MAPLE DUNES ADDITION

FINAL PLAT

Re: S/D 96-69 -MAPLE DUNES ADDITION (Final Plat)

CASE NUMBER: S/D 96-69 - MAPLE DUNES ADDITION

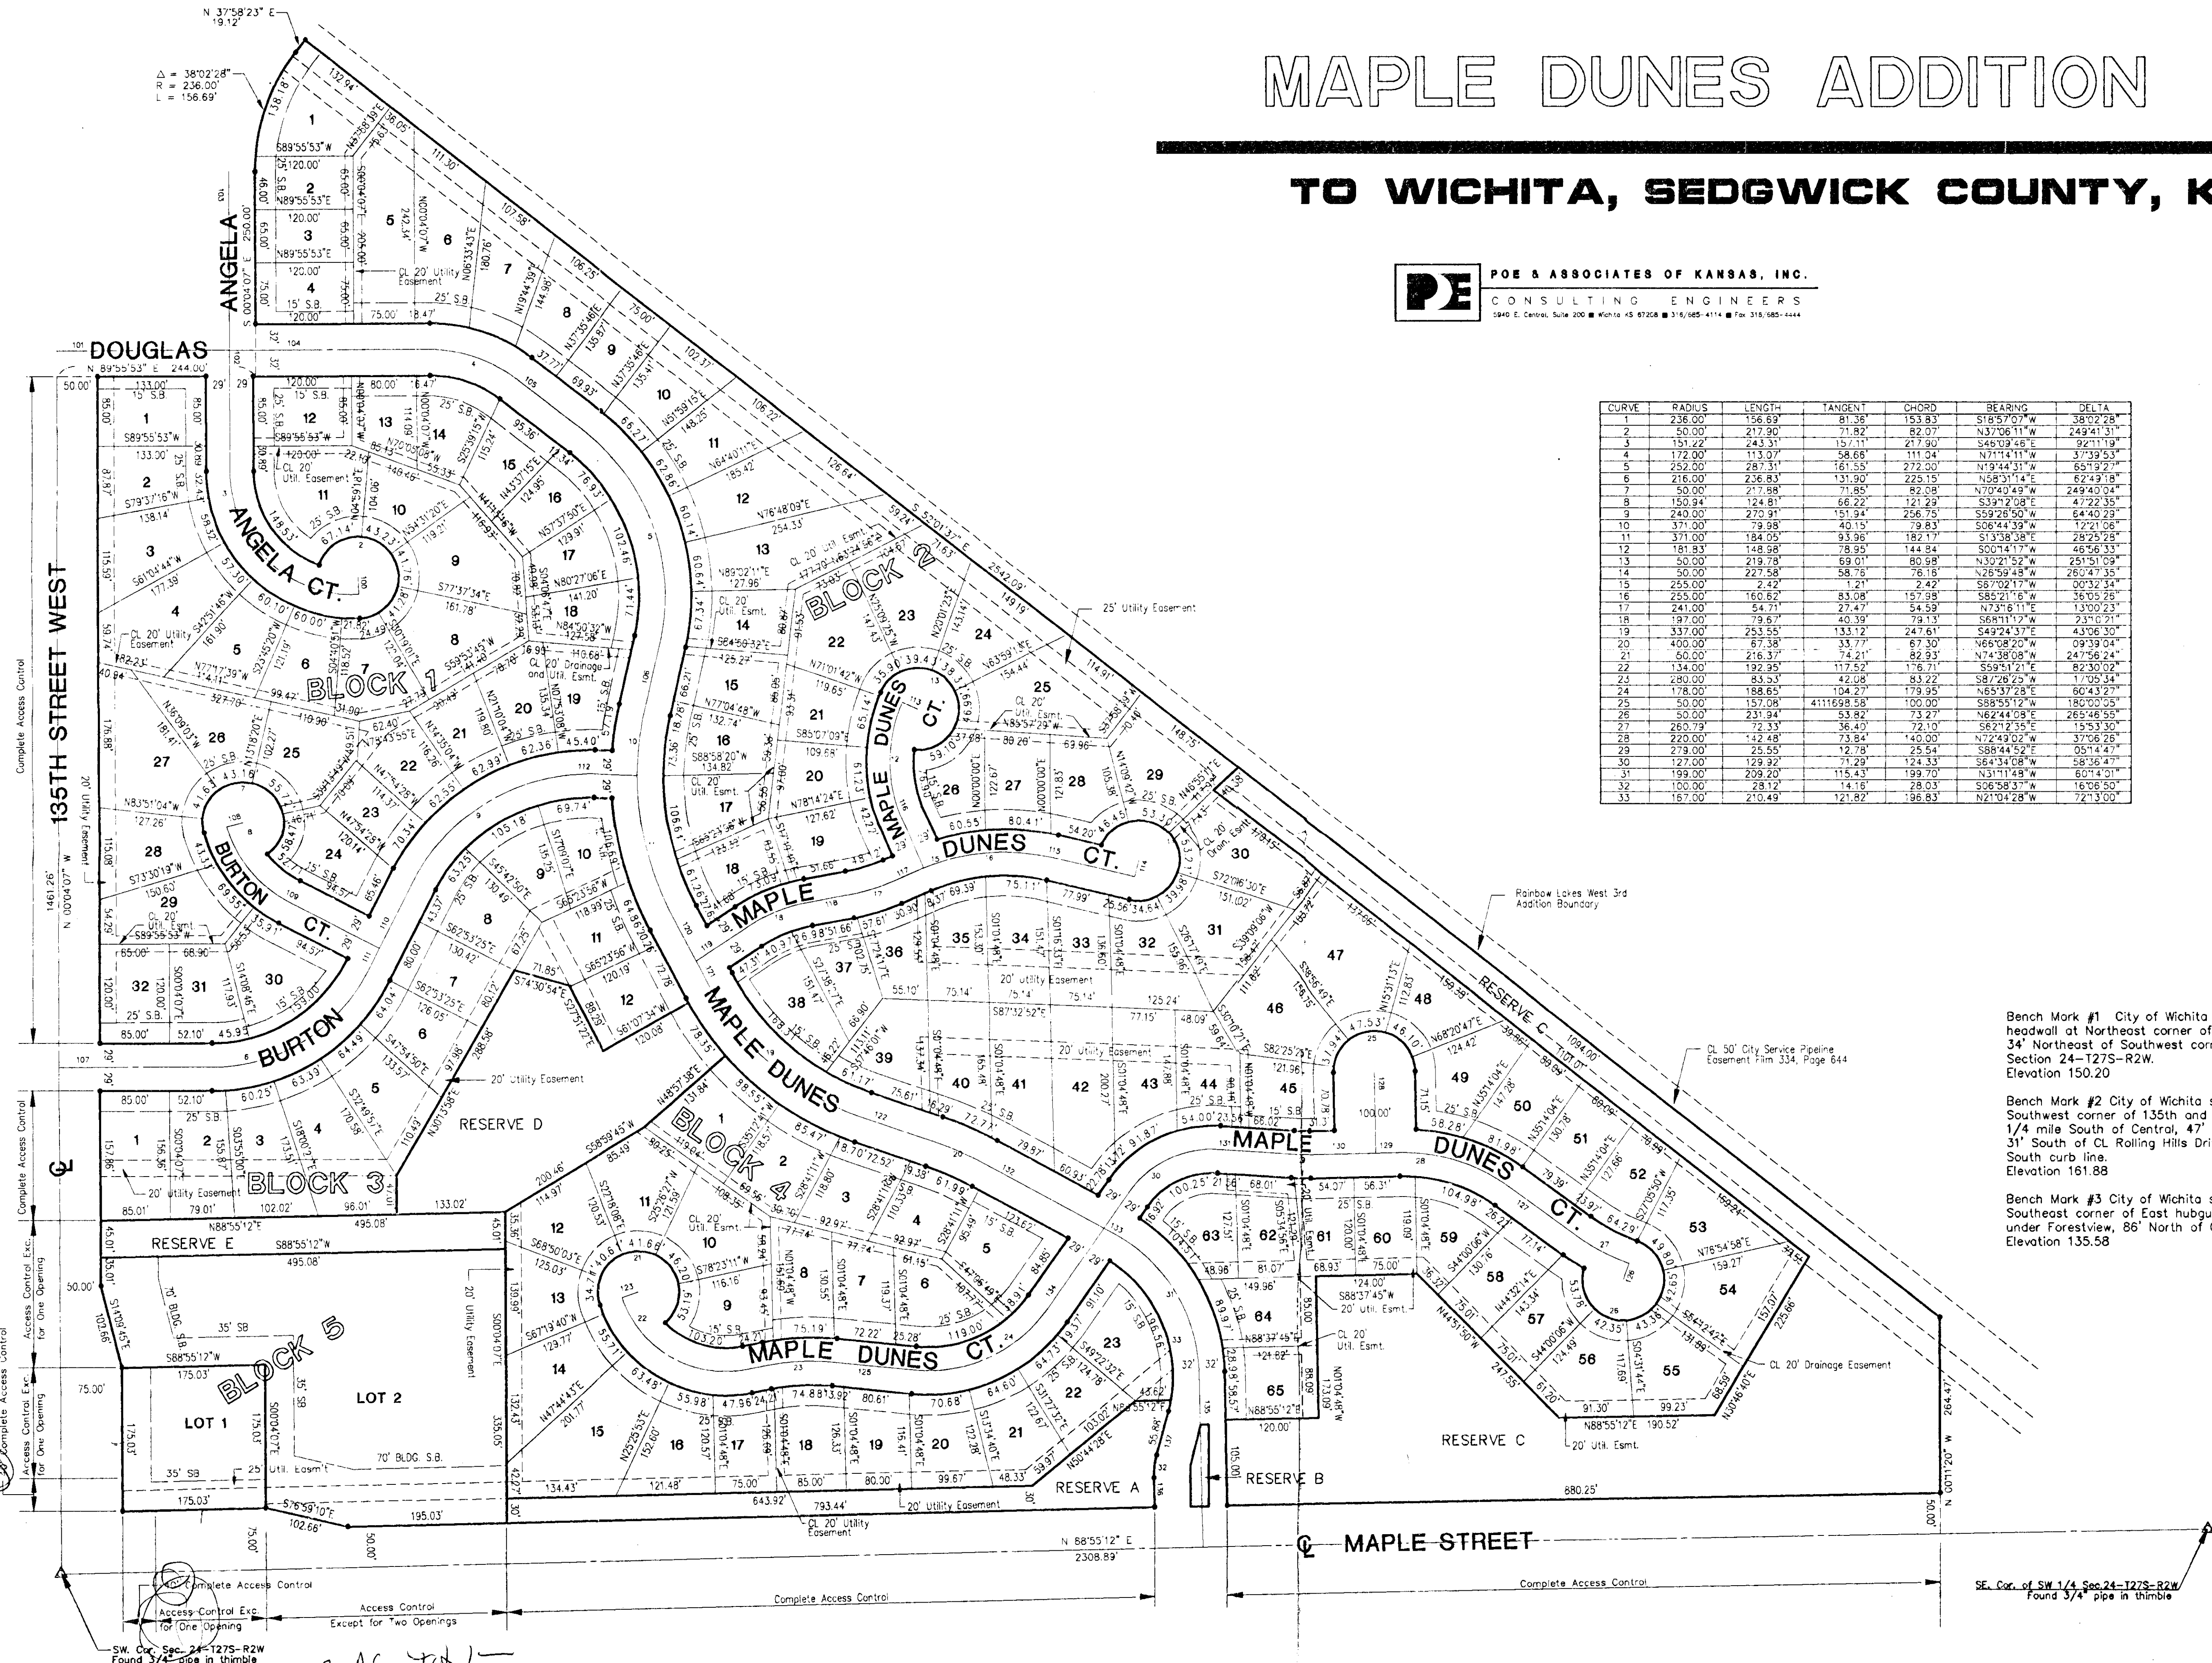
- L. On the final plat tracing, Angela, south of Douglas shall be shown as a Circle and not a Court.
- M. The applicant shall install or guarantee the installation of all utilities and facilities which are applicable and described in Article 8 of the MAPC Subdivision Regulations. (Water service and fire hydrants required by Article 8 for fire protection shall be as per the direction and approval of the Chief of the Fire Department.)

- Q. On the final plat tracing, additional dimensions from lot corners shall be indicated to better locate the easement crossing the rear areas of Lots 1 through 4, Block 3.

- S. Since Minimum Building Pad Elevations are being platted for certain lots, such requirements also need to be noted on the face of the plat. Typically, such minimum elevation requirements are at least referenced, just below the north arrow. The elevations may be listed or reference to the plat's text at least made. These elevations need to be shown in both City datum and MSL. Also, as indicated by Engineering, such elevations need to be shown for the other lots adjacent to Reserve C (Lot 30, and Lots 47 through 53).

- U. On the final plat tracing, the reference to Reserve C along the northeast line of the plat (Lots 30 and 47 through 53, Block 2) shall be clearly indicated as the area lying between the lots and this plat's perimeter. The wording "Reserve C" should either be placed within this area, or an arrow extending from the present wording in this area.

- V. On the final plat tracing, the reference to the "25 Util.Esm't and Bldg. Setback Line" along the northeast line of the plat shall further note that the Setback Line is a "Bldg. Setback Line for the City Service Pipeline." That is, the setback function of this line is not a platted setback but is rather a private matter controlled by the holder of the pipeline easement.

- James Alford, County Clerk
 - Larry Consolver, Register of Deeds
 - Michael D. Hurtt, Deputy Register of Deeds.
- X. On the final plat tracing, additional dimensional information shall be provided for the width of the opening (right-of-way) of Maple Dunes at Maple Street and to describe Reserve B at that location.

- AA. As requested by the City's Fire and GIS Departments on the final plat tracing, the street name Douglas shall be placed in the area of Lot 7, Block 2, with Maple Dunes shown from that point southward. The name Maple Dunes shall also be shown just north of the site's entrance off of Maple.
- BB. Also, as noted by City Engineering, oil well equipment, including storage tanks are shown as encumbering easements on certain lots in this Addition. Prior to this plat being scheduled for City Council review, the applicant shall submit a letter indicating that all such structures, encumbrances, etc. have been removed from any area being platted as an easement.
